IDAHO DEPARTMENT OF WATER RESOURCES
RECOMMENDATION OF WATER RIGHTS ACQUIRED UNDER STATE LAW

IDL 61 & 63 LATE CLAIMS update

Post-review follow up issues for IDL claims in basins 61 and 63.

Review notes for recommendations of late claims filed by IDL.
Sent as an attachment with email to IDL attorney, Tyson Nelson.
Steve Clelland – May 1, 2013

63-09590

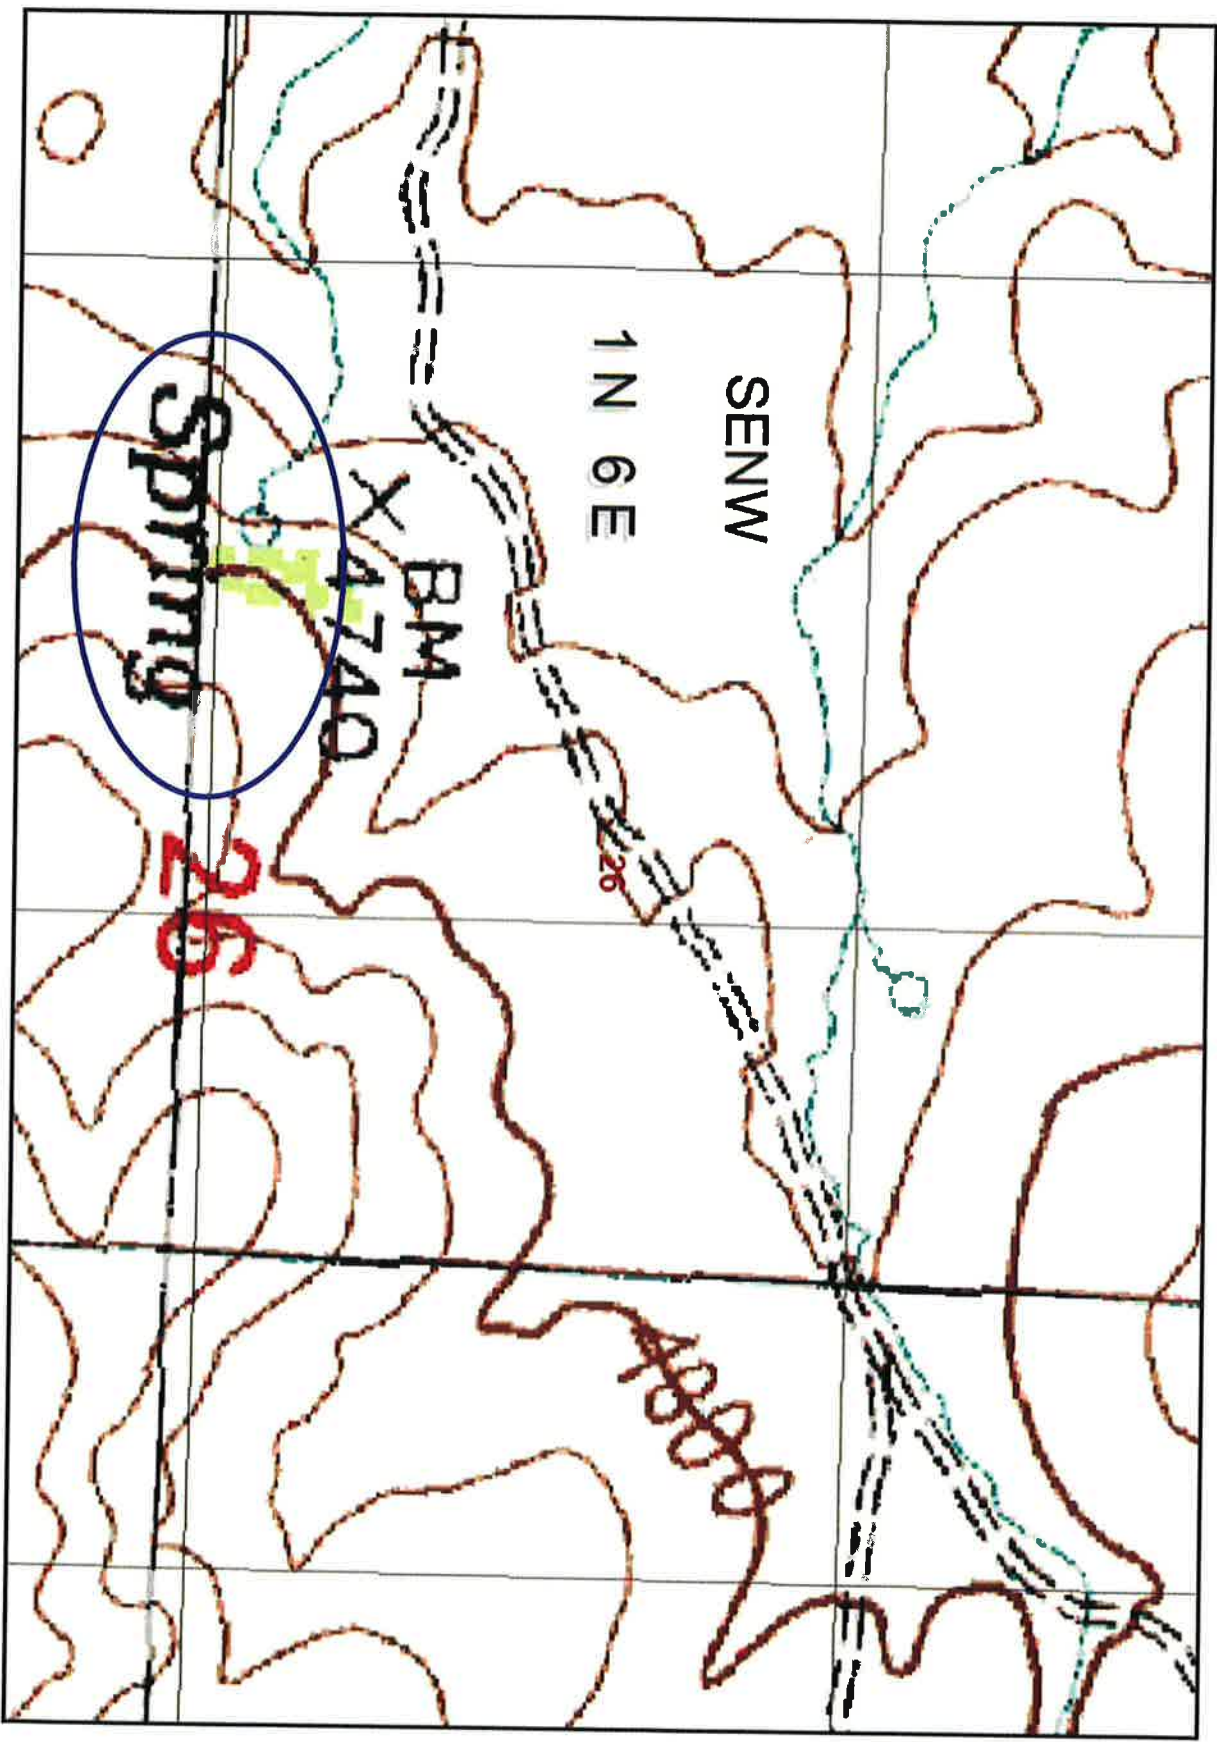
The POD and POU for this claim are described in T01N, R06E, S26, NESW. Aerial photography actually shows them being located within T01N, R06E, S26, SENW. The claim should be amended to correct these legal descriptions.

The USGS 7.5 min. Topo map shows the spring being located in T01N, R06E, S26 SENW.

63-09590

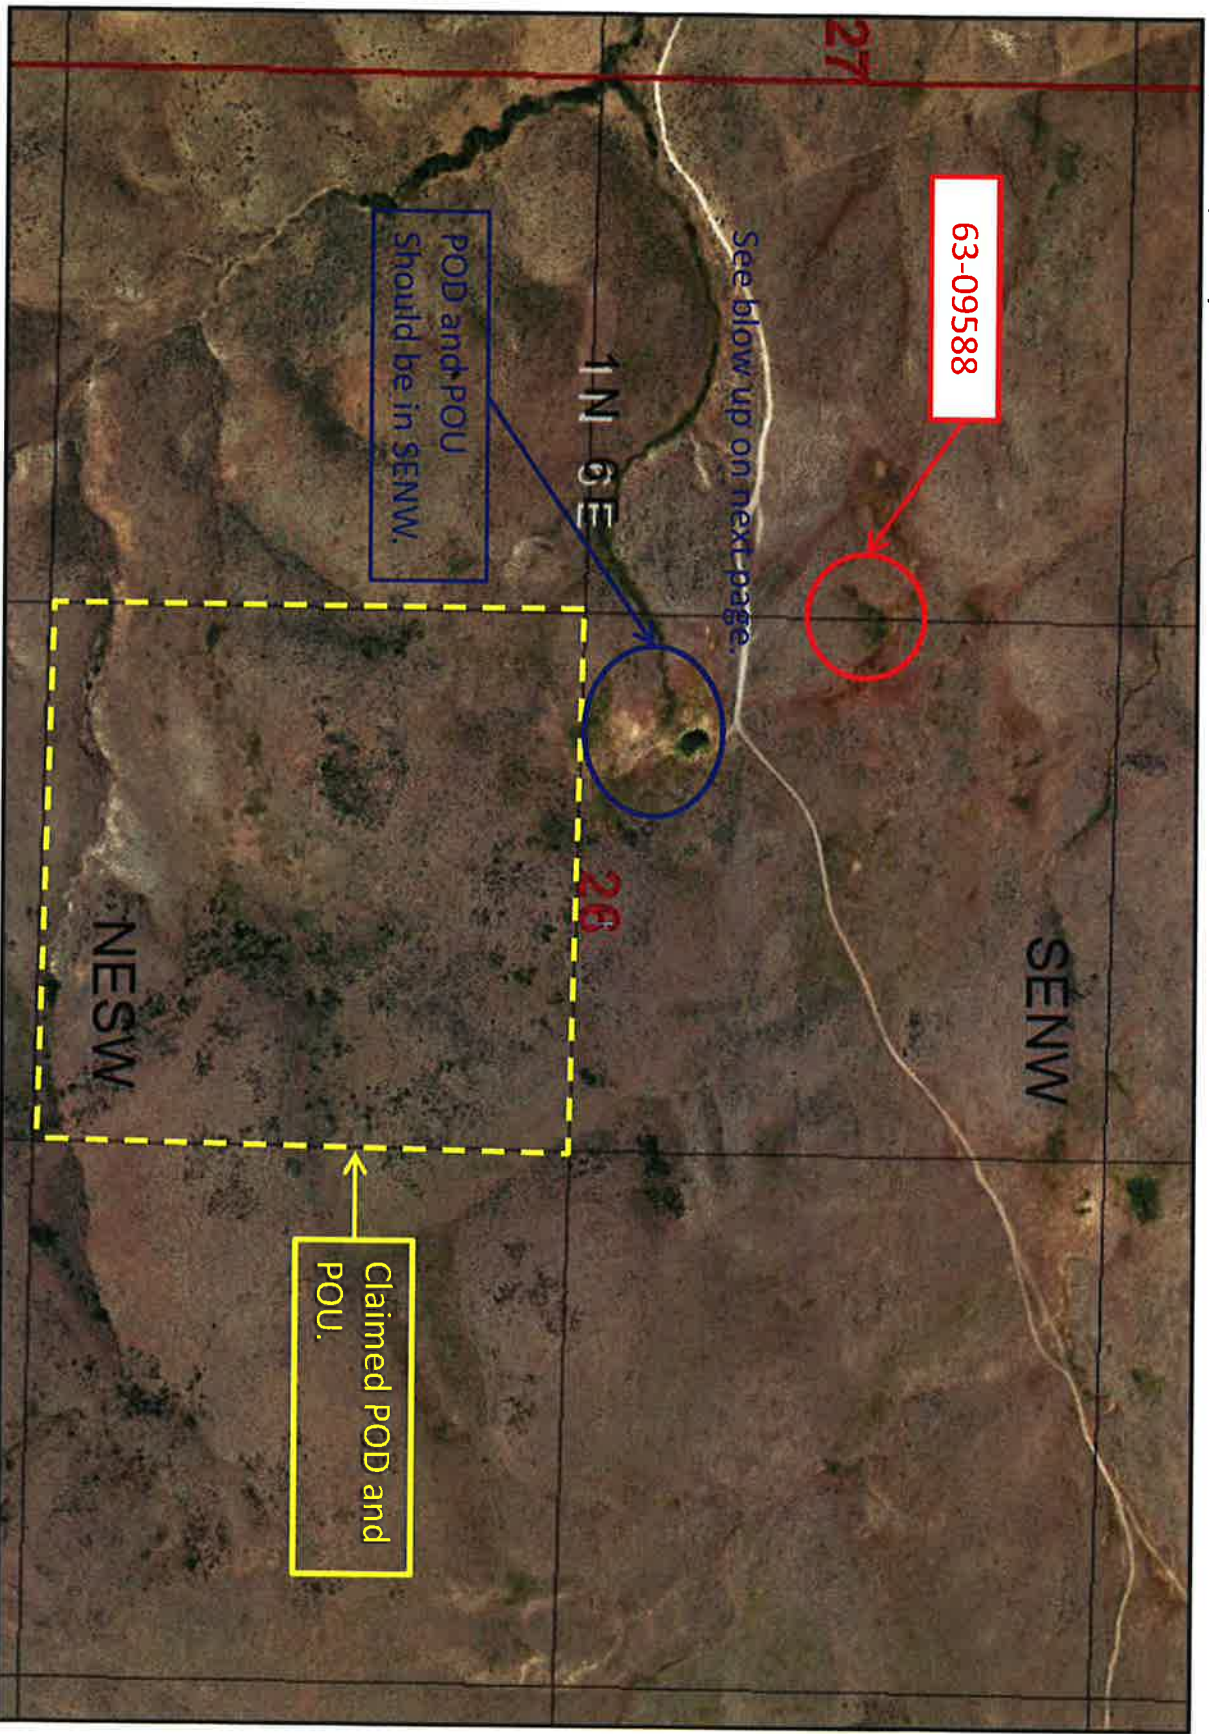
The application for permit describes a headbox in a spring and a pipe to a trough located in T01N, R06E, S26, NESW. Aerial photography shows that the spring and trough are actually located in T01N, R06E, S26, SENW.

How does this relate to 63-9588?
LEGAL: Appears to be located in SE NW
and not NESW as licensed & deeded.
(IDL # 068)

6/4/13 Updates from IDL w/ GPS data
show correct POD/POU to be
in S.26 SE NW.

63-9588 & 63-9590

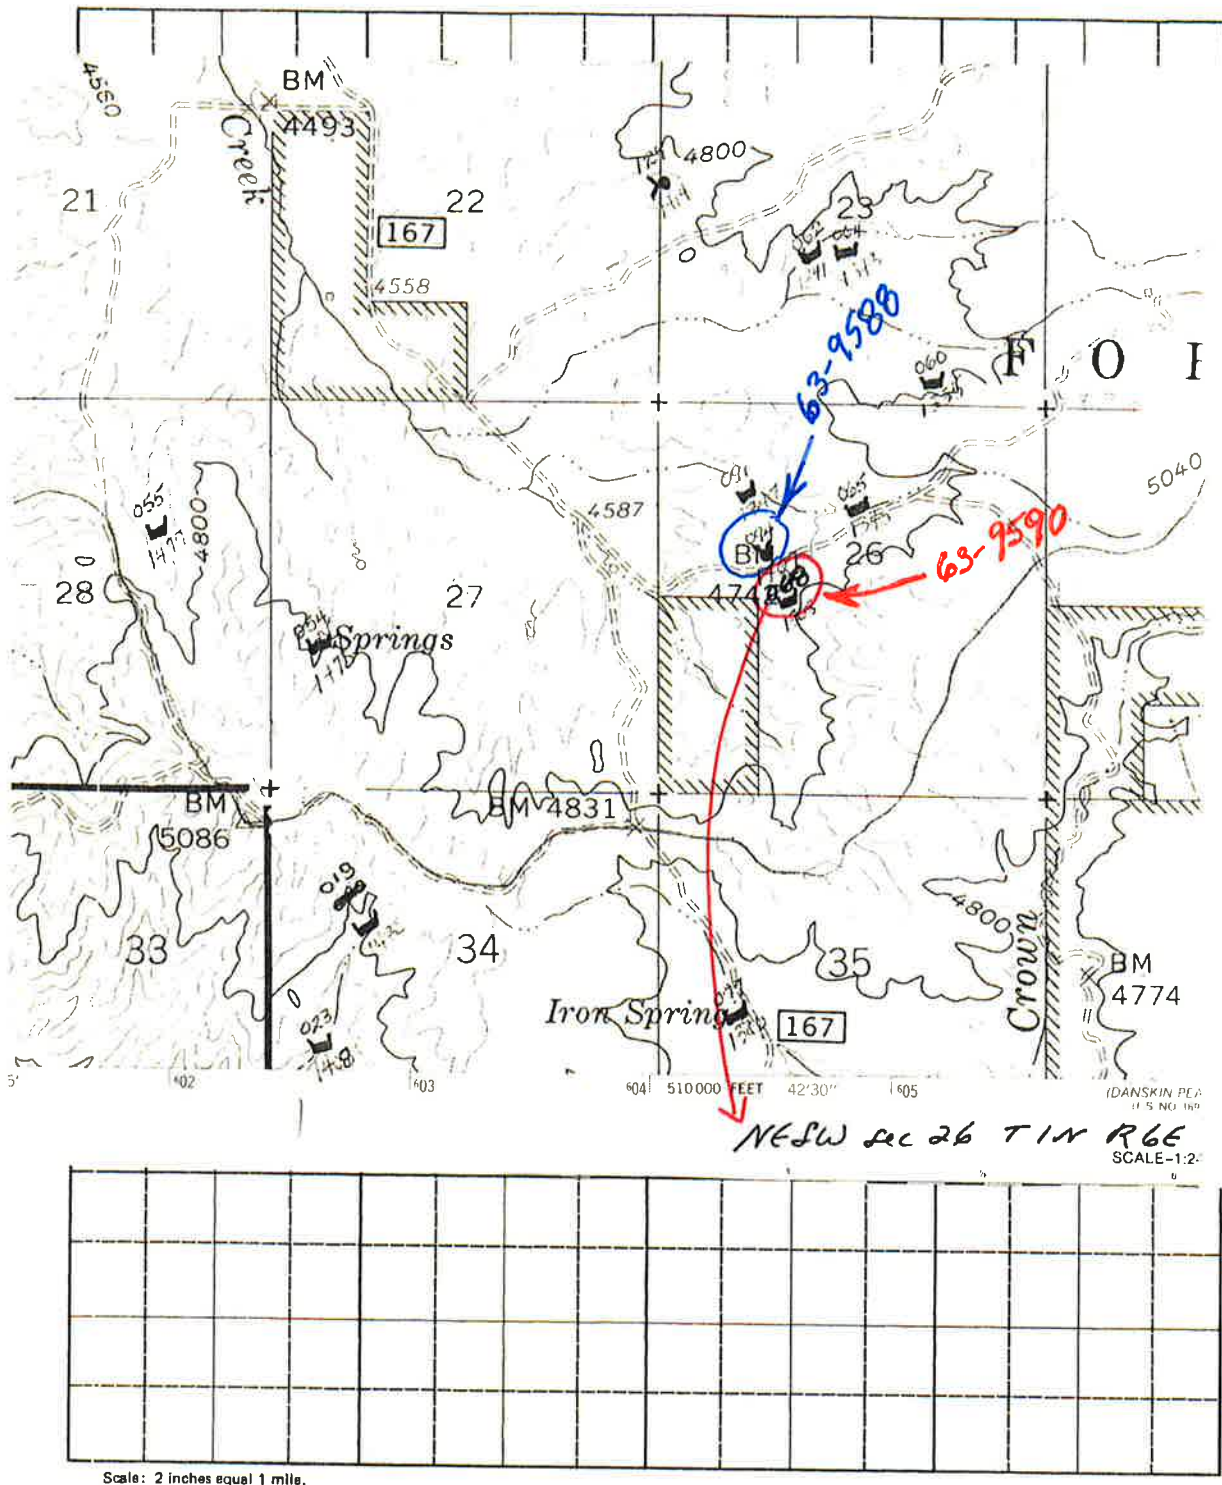
It looked as though 63-9588 was easily located on the aerial photos as claimed. There is a clearly visible pond site in the SENW (Sec. 26) which seems to match the claim and license. In the draft recommendation I have converted the purpose of use for this right to a storage type use based on the pond development. However, when beginning the review for 63-9590 I found that both these claims appear to be located in the same area. Although 63-9590 is claimed and licensed in the NESW, there doesn't appear to be any type of water source in that tract (QQ). It looks to be incorrectly described as to its location. I will need further information from IDL to explain how these two rights relate to the water sources found on the maps of the area. The right 63-9588 is for IDL#094 and 63-9590 is for the IDL#068 as identified on the Backfile map. <See photo and rec'd for 63-9588>

63-9590

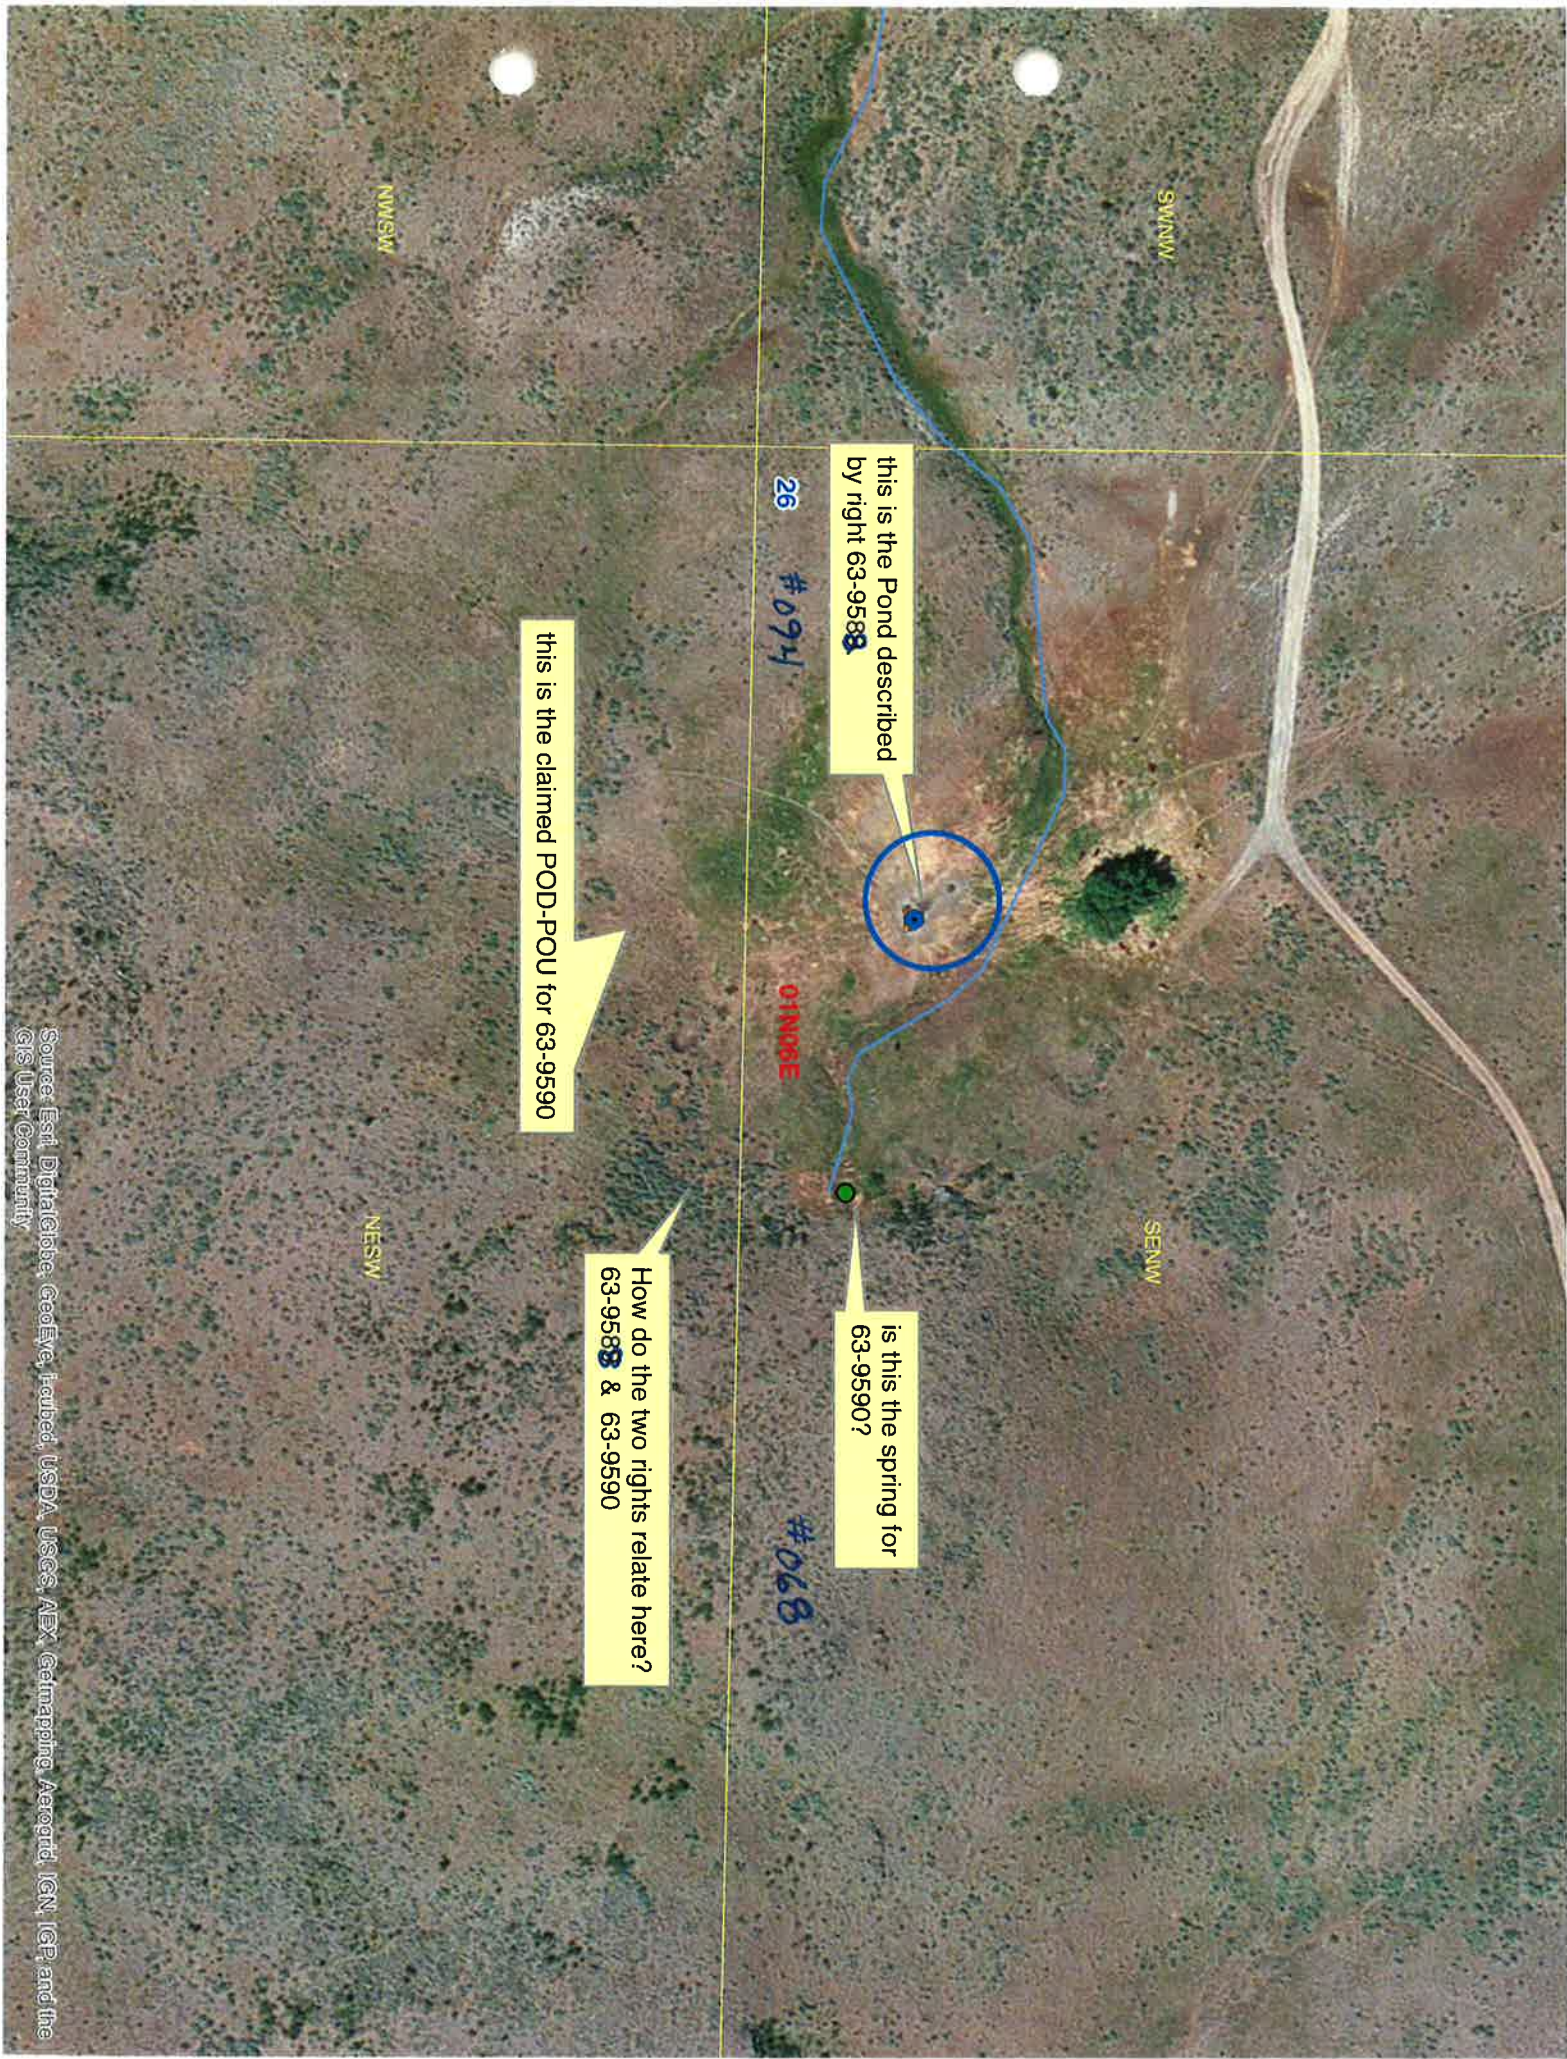
this is the Pond described
by right 63-9588

is this the spring for
63-9590?

this is the claimed POD-POU for 63-9590

How do the two rights relate here?
63-9588 & 63-9590
